Work Order ID 145688

Item Name: Replacement Skidtube (Fits LH or RH)

DRAWING NO. D2650	TITLE 206/407 SKIDTUBE ASSEMBLIES	REV. F	DART AEROSPACE LTD ENGINEERING ORDER		D.E.O. NO. D2650-F-1	SHEET NO. SHEET 1 OF 1	SCALE NTS
DRAWN <i>[Signature]</i>	CHECKED <i>A.P.</i>	MFG. APPR. <i>[Signature]</i>	APPROVED <i>[Signature]</i>		DE APPR. <i>[Signature]</i>		
DATE 12.10.12	DATE 12.10.22	DATE 12.10.22	DATE 12.10.22		DATE 12.10.22

CHANGE C'BORED WELDED CROSSBOLT SPACERS TO SWAGED SPACERS

DETAIL G

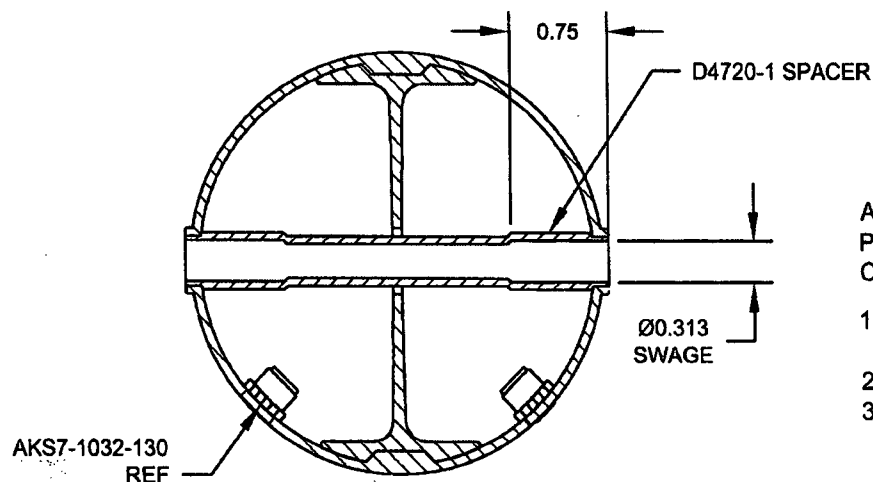
ADD DETAIL G BELOW, WHICH IS THE SAME SECTION VIEW AS DETAIL D OF DWG.
C'BORED HOLES ARE **NOW SWAGED** PER DETAIL G BELOW. FOR THE Ø0.375 HOLE THAT IS NOT C'BORED, WELD PER DETAIL D OF DWG (SEE AMENDED DETAIL B FOR REFERENCE).

D2649 SPACER,
WELD PER DETAIL D OF DWG
BUT DO NOT C'BORE
